**DATE:** April 14, 2025

**REPORT NO:** PD-16-2025

**SUBJECT:** **Application for Block Plan (Block 9 (4000-01-24); Zoning By-law Amendment (1601-008-24); Draft Plan of Subdivision (2000-93-24); Lockbridge Development Inc., TEK Corporation and the Trustee for Judy Hendler**

**Figure 3: Comparison of OPA 63 MCP Block Plan and Proposed Block Plan**

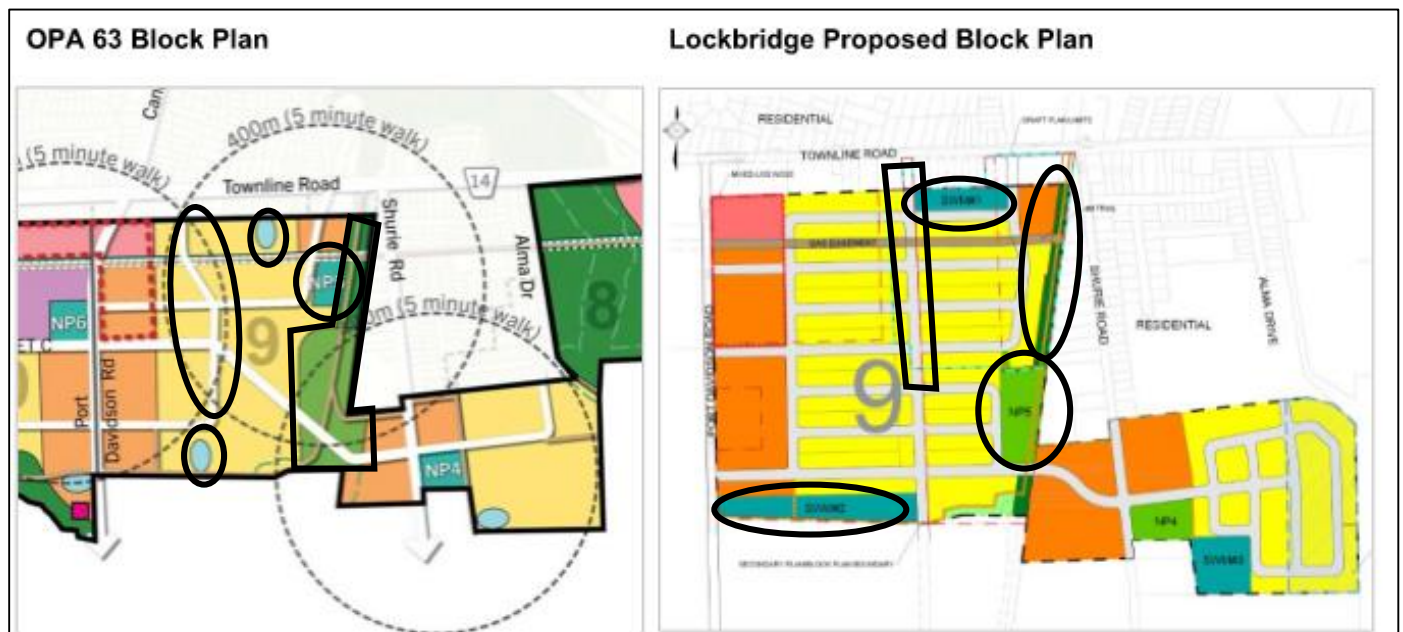
The image above shows four distinctive modifications from the OPA 63 Block Plan:

- Stormwater Management Pond – the location of the stormwater management pond is generally in the same location in the proposed Block Plan for Lockbridge but shows a significantly larger pond for the southwest quadrant of the block plan.
- Neighbourhood Park (NP5) – the location of the neighbourhood park was relocated south and consolidated within the recommended restoration area which is completely outside of the Lockbridge development that is subject to the applications submitted for approval. It would be challenging to combine a restoration area and park, as there would be significant limitations to locating playgrounds, trails and sports facilities within an area that is to be naturally restored.
- Restoration Area and Corridor Linkage – the restoration areas and corridor linkages

identified in the MCP sub-watershed study are those areas necessary to provide native plantings to restore habitat and naturalized corridors for significant species and being a minimum of 50 metres wide and along the former rail corridor. Reductions of these restoration areas and corridor linkages can be modified subject to the completion of the environmental assessments approved by the Region and the Conservation Authority. The proposed Block Plan generally kept the location of the corridor linkage but with a reduced width varying between 23 – 27 metres. The restoration area has been relocated south outside of the proposed Block Plan for the Lockbridge development and combined with the park, which would create significant challenges.

- Transportation Network – the proposed Block Plan for Lockbridge shows a varied transportation road network which is slightly different to that of the Transportation Master Plan which lends itself to propose lots fronting on a proposed collector road. These lots should be oriented in the same pattern as the balance of the proposed lots.

Figure 4: Proposed Draft Plan of Subdivision

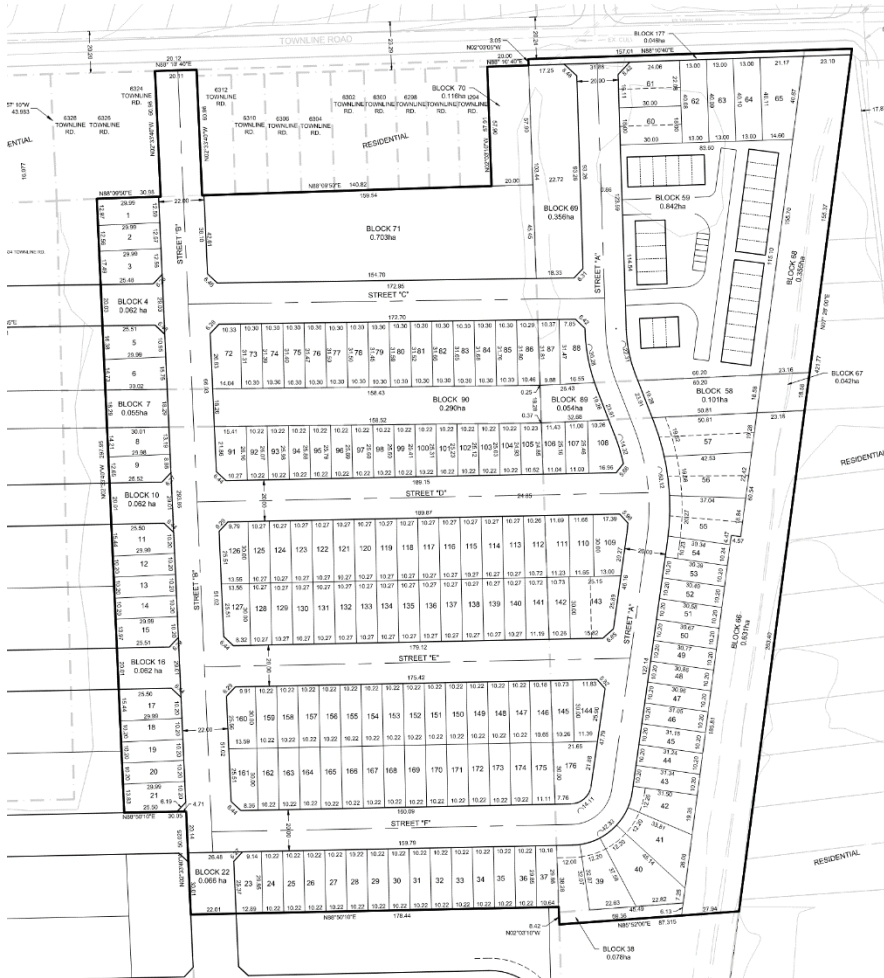
- Concerns for the future safety and operating efficiency of the proposed local collector road that runs from Townline Road to the southern limit of the Block Plan area (identified as Street B on the Draft Plan of Subdivision). As the lands to the west of

- The sub-watershed study (SWS Phase 2 Report (Wood, 2022a), identified a secondary linkage, 50 metres in width, identified along the entire length of the eastern property boundary. The EIS does not dispute the 50-metre width; however, the Draft Plan of

- Subdivision appears to only show a 23-metre-wide linkage.
- A restoration area was recommended in the subject lands; however, the EIS does not include the recommendation for a restoration area in the proposed Lockbridge development. If a restoration area is not proposed, thorough justification will be required to explain how additional field surveys have informed this new conclusion and how the Block Plan area will achieve the 30% natural cover objective described in OPA 63.
